#### **Appendix J**

Truckee River Flood Management Authority and National Weather Service Memorandums and Presentation

Subject: Channel Capacity during sustained high streamflows along the Truckee River.

# Truckee Basin Water Management Options Pilot Study—Channel Capacity Analysis

6500 cfs sustained

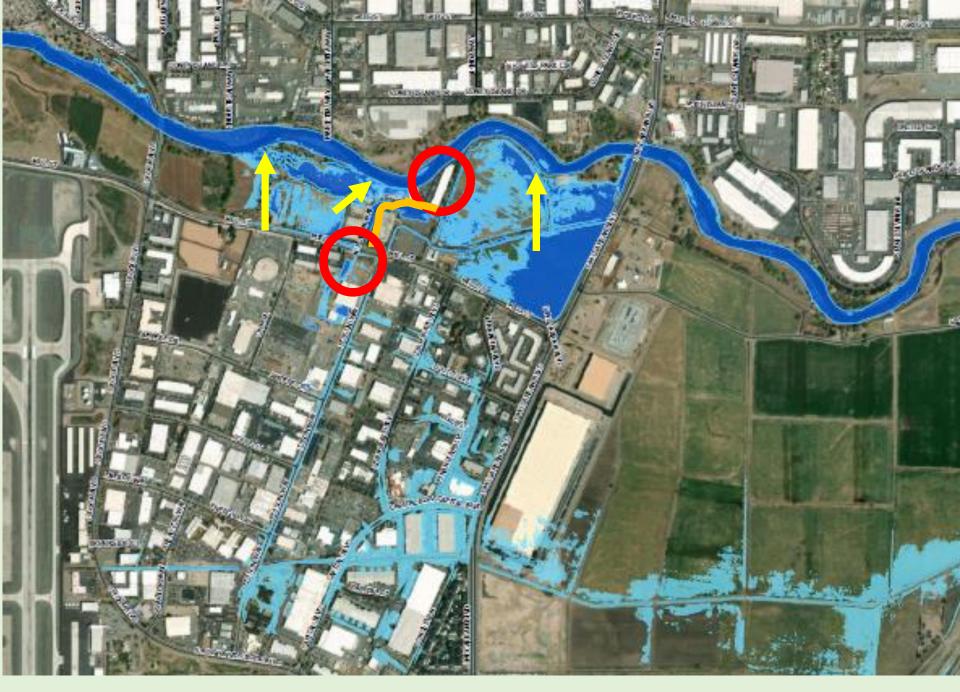
- 1. Only additional breakout near Lockwood minor flooding in undeveloped land.
- 2.In the Rock/McCarran Blvd Reach there is additional flooding
- 3. Ponds against but does not overtop roadway on Mill Street

7000 sustained

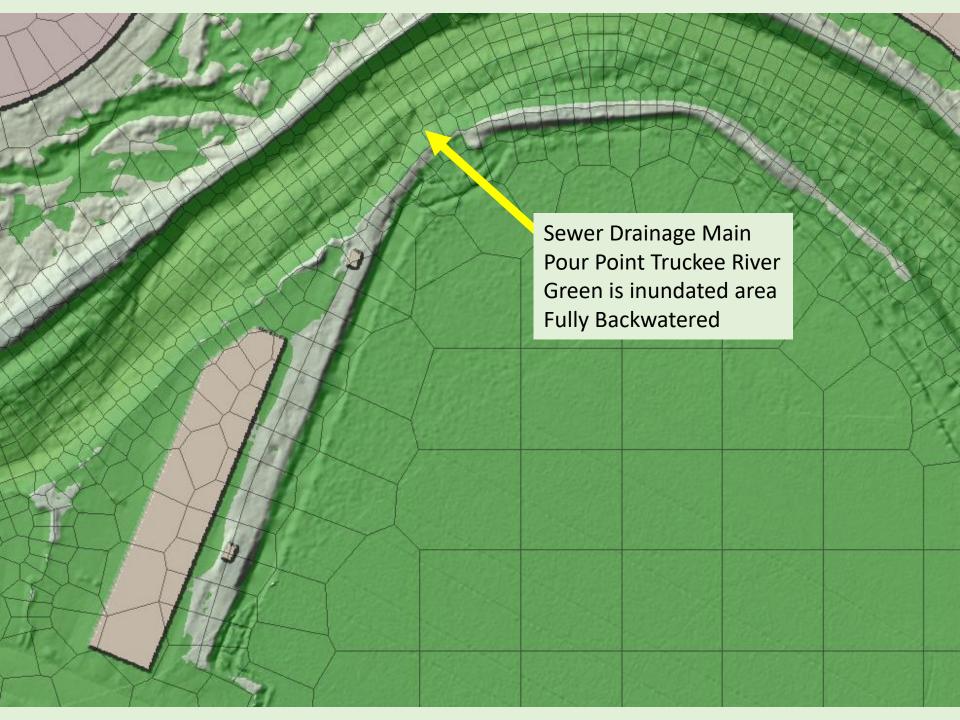
- 1. Only additional breakout downstream of Vista Undeveloped area. In the Truckee Meadows Reach around Reno.
- 2. In the Rock Blvd Reach there is additional flooding and model shows overtopping Mill Street into Energy Way.
- 3. Four additional breakout in downstream reach but undeveloped.

7000 cfs

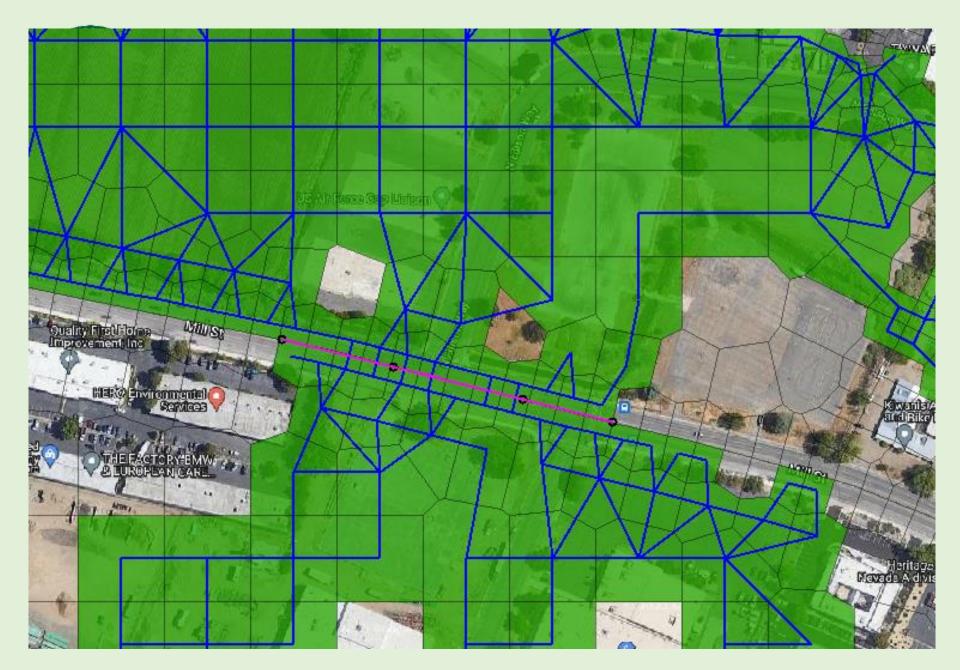
- 1. The capacity of the drainage main is likely greater than the breakout flow.
- 2. This is the reason that in photos with larger floods we do not see it breaching Mill Street
- 3. Because Edison gets flooded fairly significantly at 7500 cfs, I think 7000 is justifiable but probably not 7500 cfs.
- 4. Need to get the actual breakout rates to absolutely verify all this but they are likely less than water main.

7500 cfs

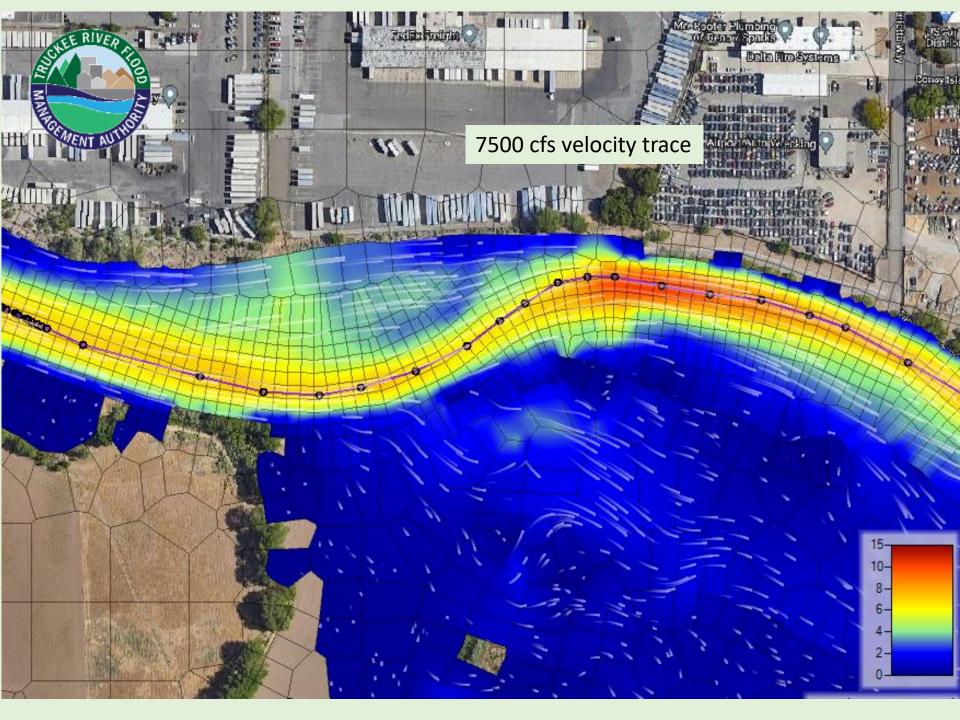
- 1. New Breakouts around Reno include overbank near McCarran Bridge on North Bank
- 2. Lower Reach has an additional breakout at 2 locations on near Lockwood and the other near Derby Dam. Small breakouts with no developed land threatened.
